RE: **PETITION NO. 980** - BNE Energy, Inc. petition for a declaratory ruling that no Certificate of Environmental Compatibility and Public Need is required for the construction, maintenance, and operation of a 3.2 MW Wind Renewable Generating facility located at 178 New Haven Road, Prospect, Connecticut.

PRE-HEARING INTERROGATORIES

PETITION 980 - PROSPECT

SET FOUR

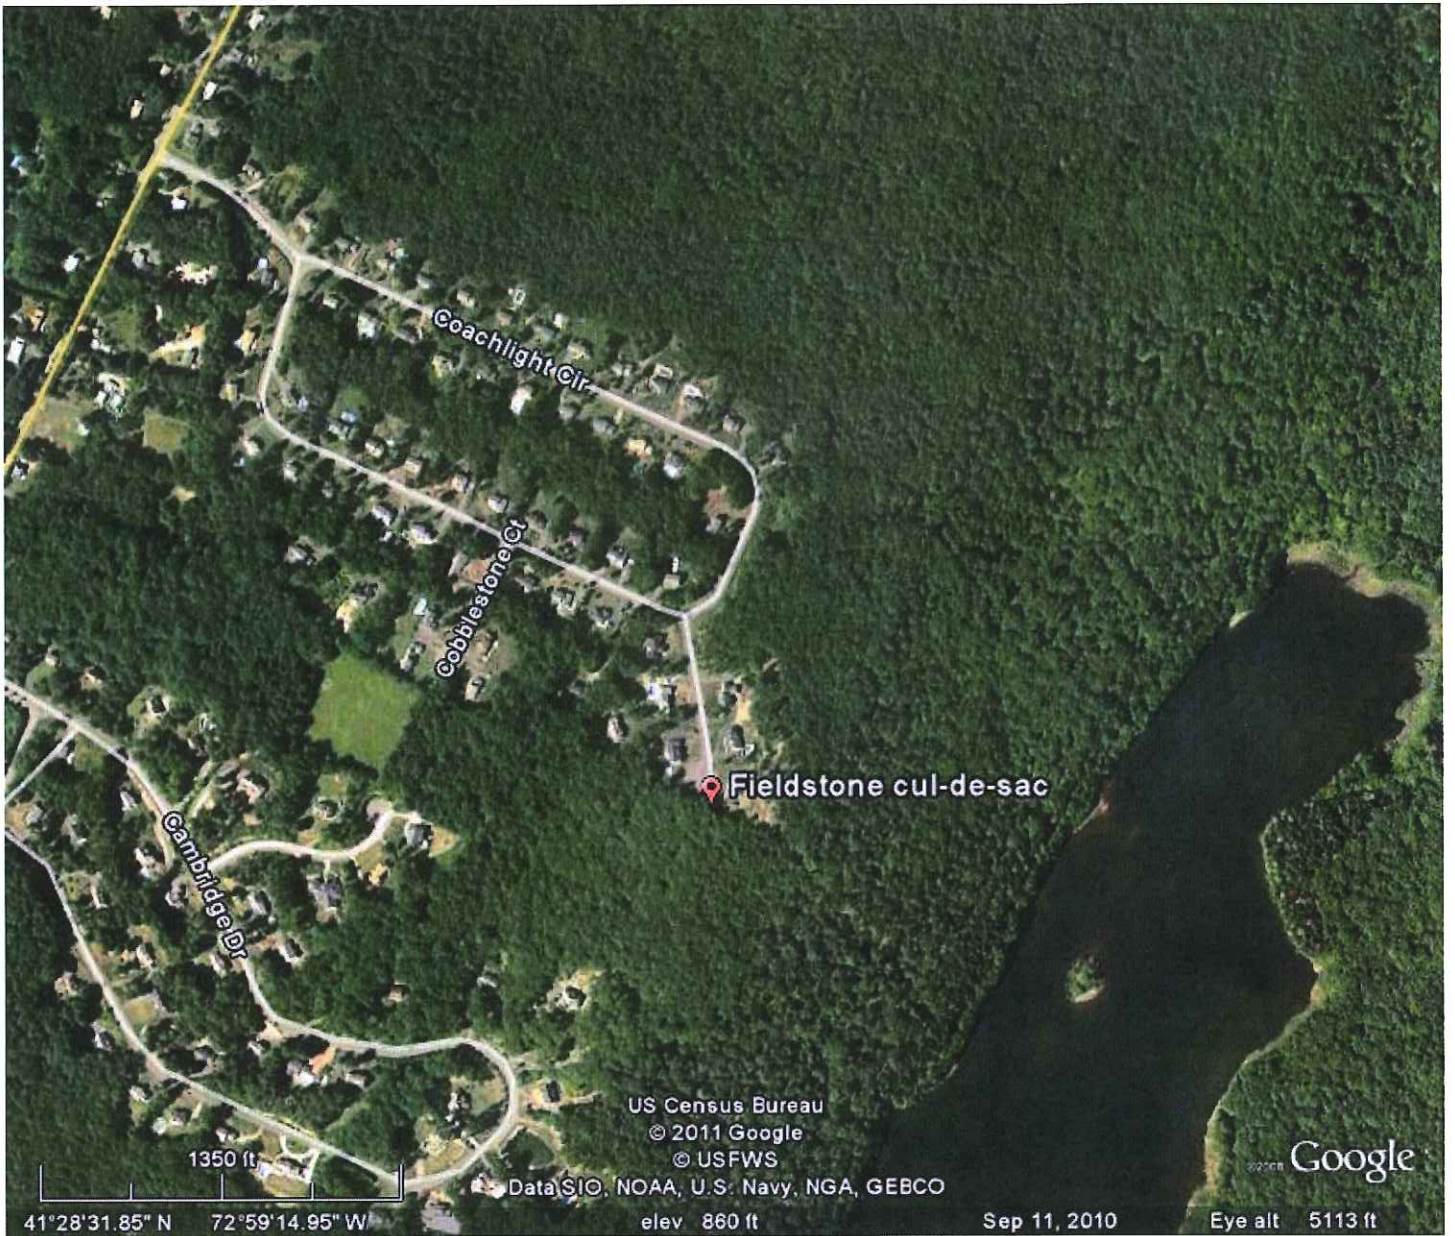
50. Provide photo-simulations of the proposed turbines, similar to the ones provided in Petition Exhibit J, in areas of year-round visibility, including but not limited to the locations marked on the attached map.

51. Would the proposed turbines be visible from Lee Road extending from George Street to Route 69 (generally), or from the George Road and Route 69 intersection area? If so, why were these areas omitted from the visibility analysis?
